Henry + Associates Project No. 21-32-051

ADDENDUM NO. 01
Fencing-Lakewood ES Modernization
Lodi Unified School District
Lodi, California

AD1.01 REPLACES sheet A1.1.2
AD1.02 REPLACES sheet A1.3.2

1 SITE PLAN
A1.1.2

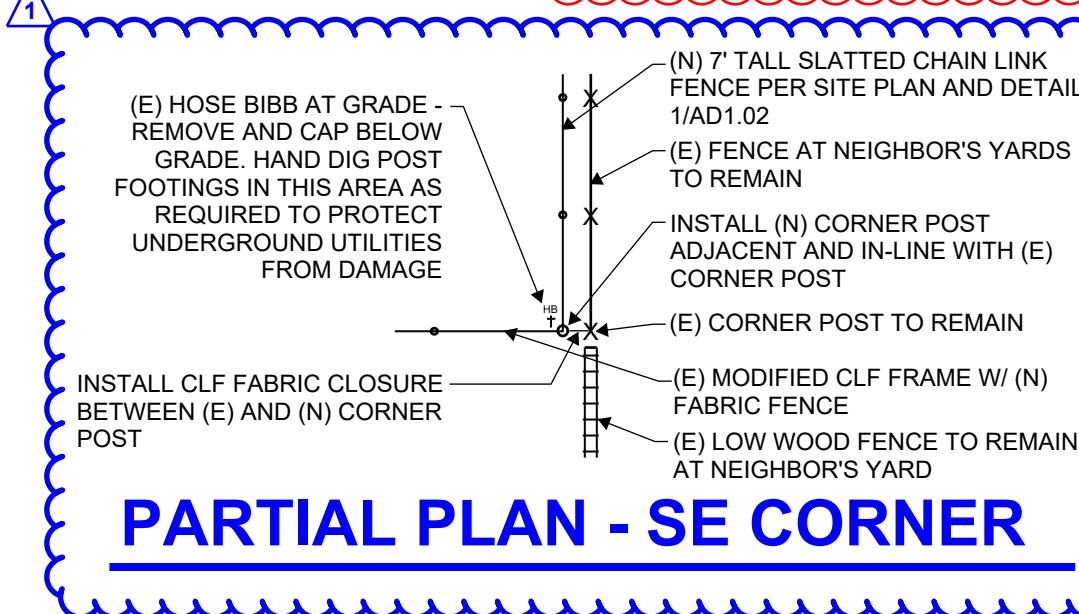
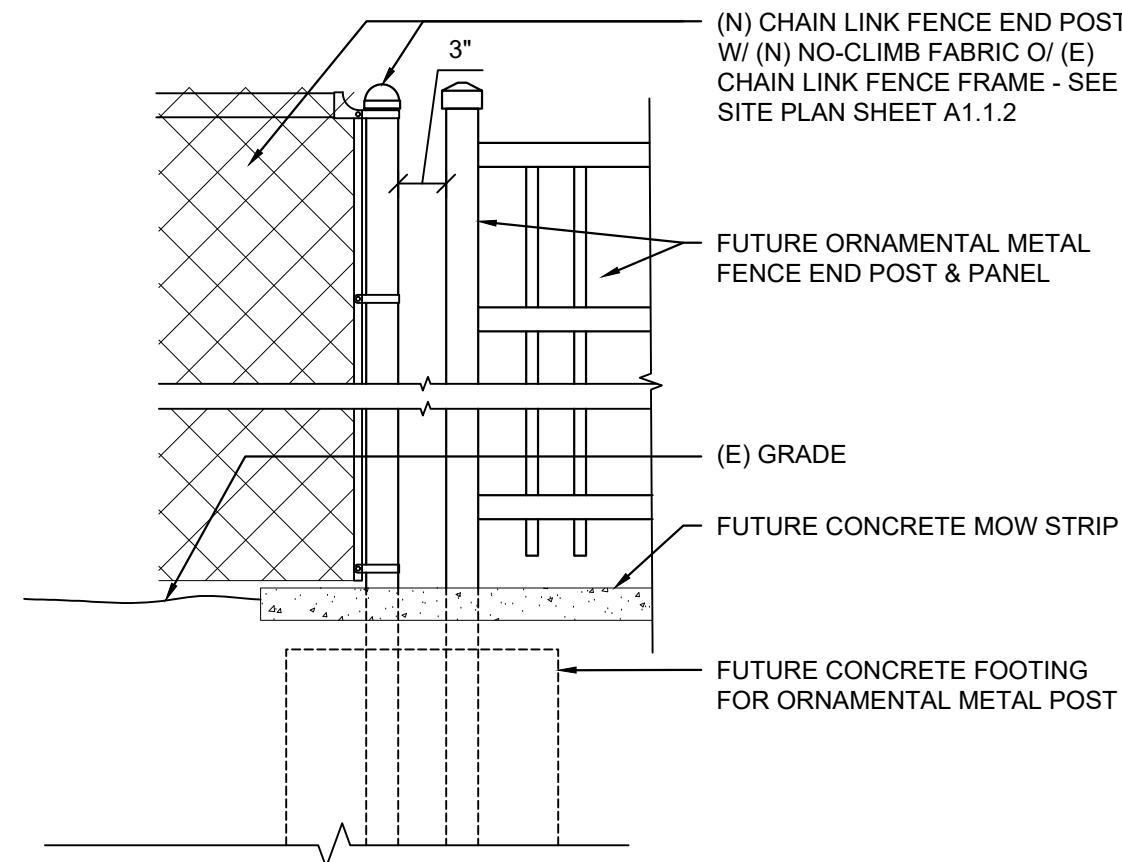
INSTALL (N) END POST AT THIS LOCATION WHERE CHAIN LINK FENCE TRANSITIONS TO FUTURE ORNAMENTAL IRON FENCE - SEE DETAIL 11/A1.3.2 - VERIFY EXACT LOCATION WITH ARCHITECT

(N) FENCE HEIGHT TO MATCH (E) LOWER FENCE HEIGHT (4' +/-) AND LENGTH AT THIS SHORT FENCE SECTION AT STREET

REMOVE (E) END POST AND CLF FABRIC THAT ABUTS THE (E) WOOD FENCE THIS LOCATION. INSTALL (N) END POST JUST INSIDE OF (N) SLATTED 7' FENCE. REINSTALL FABRIC. INSTALL SO THAT THIS (N) END POST AND CLF CAN BE REMOVED DURING FUTURE SITE IMPROVEMENT WORK WITHOUT ADJUSTING OR DAMAGING THE (N) SLATTED CLF.

NOTE: IN ADDITION TO SCOPE DESCRIBED IN NOTE SN.09 AND SN.10, CONTRACTOR IS REQUIRED TO REPLACE ALL (E) CORNER, END, GATE OR OTHER FENCE POSTS THAT PROVIDE LATERAL TENSION OR STRUCTURAL INTEGRITY TO THE (E) FENCE LINE WITH (N) POST AND FOOTING AT 7' FENCE HEIGHT. PROVIDE NEW HORIZONTAL OR WIRE BRACING FOR A COMPLETE LATERAL BRACED SYSTEM.

INSTALL (N) FENCE POST AND TRANSITION FROM SLATTED FABRIC AT EAST PROPERTY LINE TO NO-CRIMP FABRIC AT SOUTH PROPERTY LINE

INSTALL (N) 12' WIDE X (N) FENCE HEIGHT ROLLING CHAIN LINK FENCE GATE. VERIFY EXACT LOCATION AND ORIENTATION WITH DISTRICT & ARCHITECT PRIOR TO FABRICATION AND INSTALLATION. PROVIDE END POSTS AND CONCRETE PAVING SECTION FOR WHEEL TRACKING - SEE DETAIL 12/A1.3.2

ROLLING GATE TO BE 12' CLEAR WIDTH AND TO BE CENTERED BETWEEN THE (E) MOST EASTERLY LARGE TREE ON THE STREET SIDE OF FENCE AND THE ADJACENT NEWLY PLANTED SMALL TREE ON THE PLAYFIELD SIDE OF FENCE.

ROLLING CHAIN LINK FENCE GATE

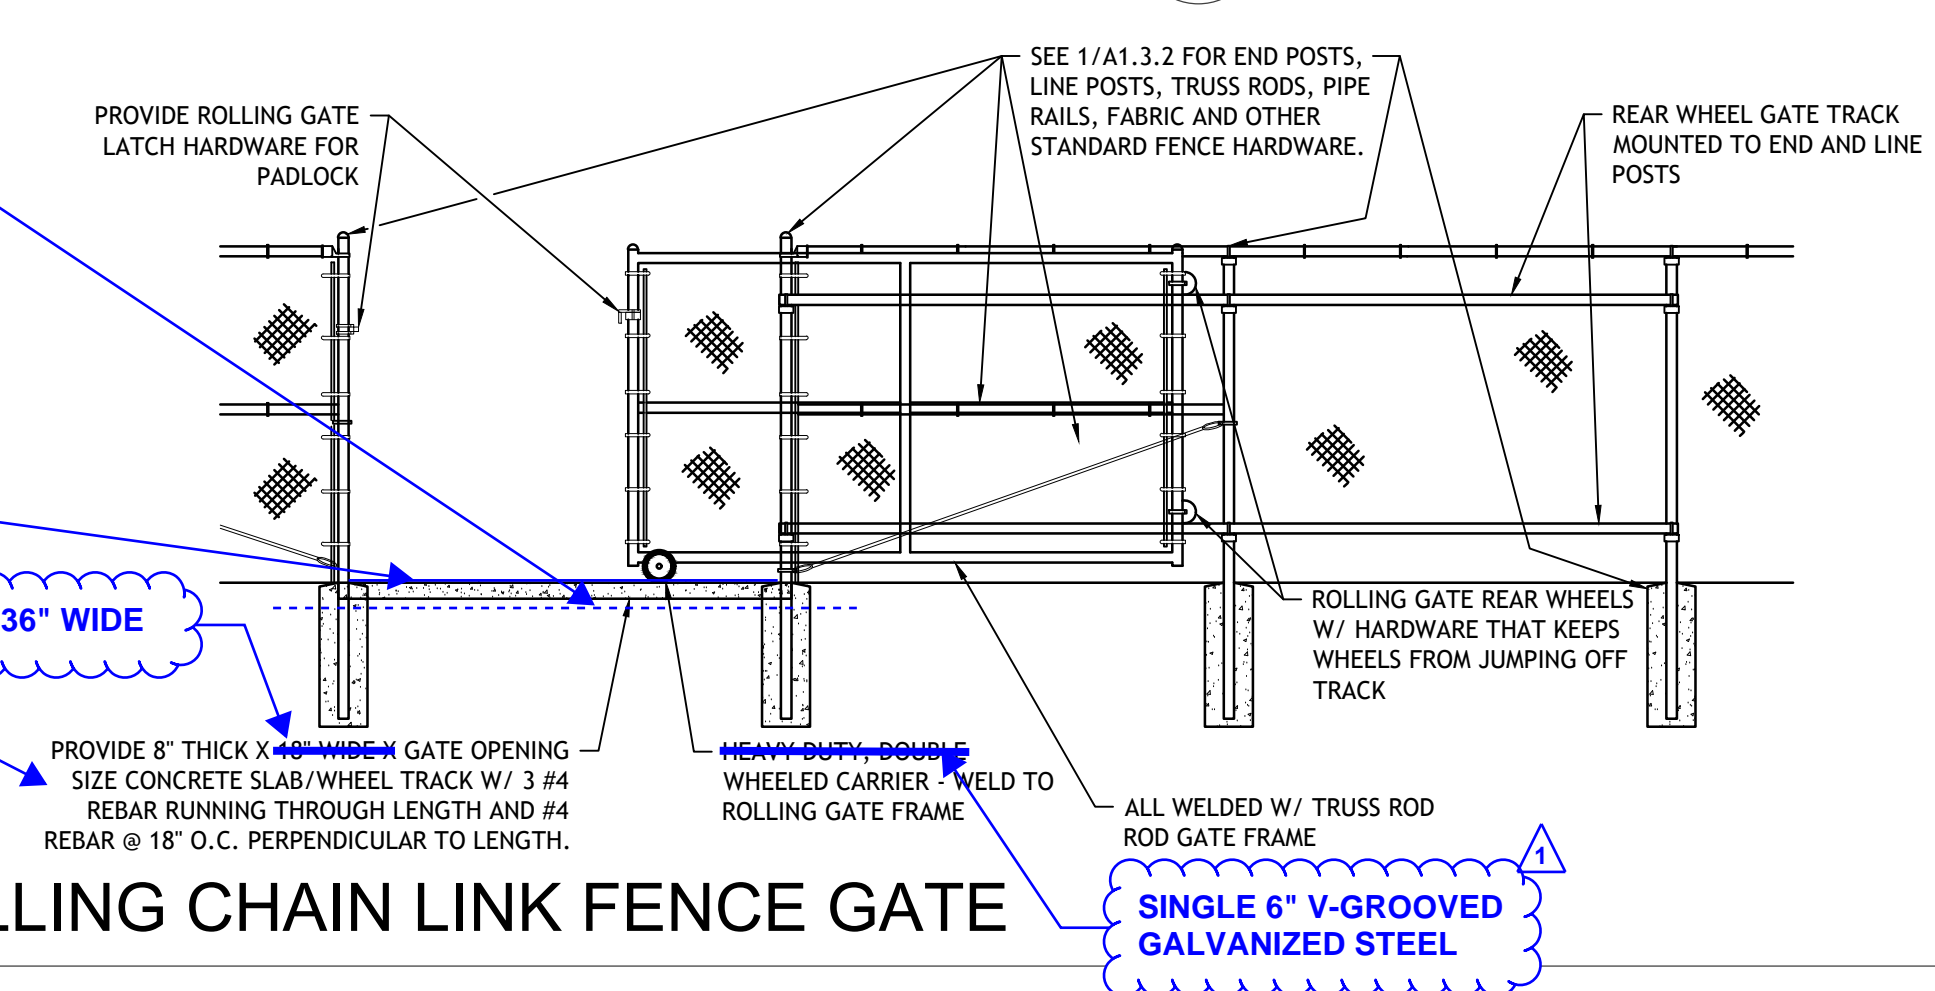
4. DELETE paragraph 2.03, K. The rolling chain link gate is not a single cantilever slide gate. The rolling chain link gate is to be fabricated using galvanized pipe and other components as indicated in the details and as per the CalTrans standard as specified in the Fence, Post and Gate Notes, detail 8/AD1.02.
